Service Bulletin

Subject: Revised Front License Plate Bracket Installation Instructions

Models: 2014 Cadillac CTS Sedan
with Front License Plate Mounting Package (RPO VK3)

Revised License Plate Bracket Installation Instructions

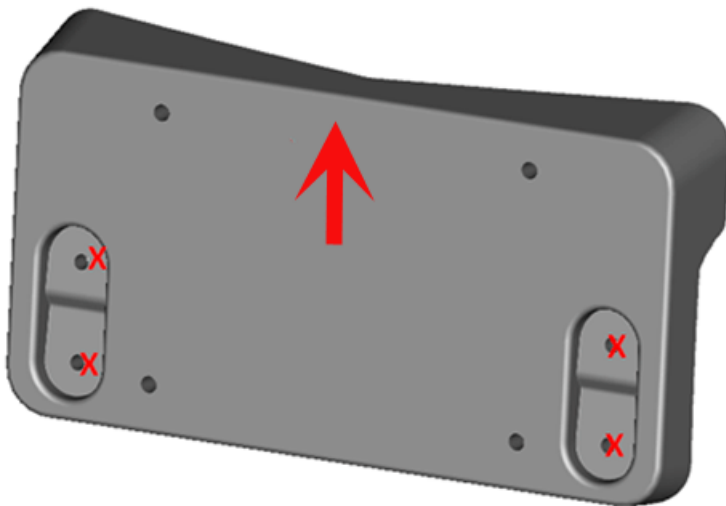
The installation of the front license plate bracket (if equipped) has been revised for better retention. Do NOT use the rivets included in the trunk bag for installing the Front License Plate Mounting Package (RPO VK3). If bolts and u-nuts are included in the trunk (small package with instruction sheet), use those to install the bracket following the instructions below. If bolts and u-nuts are not in the trunk, order four (4) bolts and four (4) u-nuts to install the front bracket. Reference Parts Information section below.

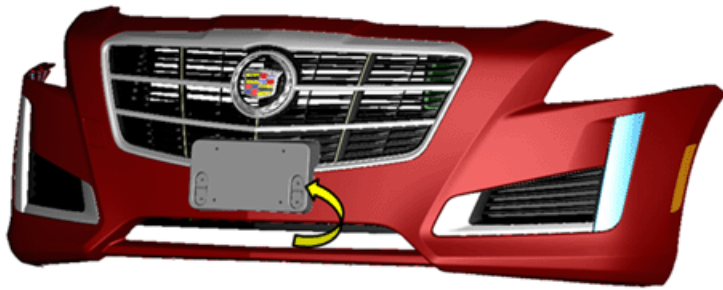
1. Drill 5.0 mm holes in all 4 location holes in bracket marked "X"

2. Install bolts through the license plate bracket and fascia holes.

3. Reach inside and behind the fascia (through the lower fascia opening) and install u-nuts on the backside. The u-nut is being used only as a nut. It does not clip on to any body parts.
4. Tighten bolts into the u-nuts with a torque of 22 in-lbs. (2.5 Nm).
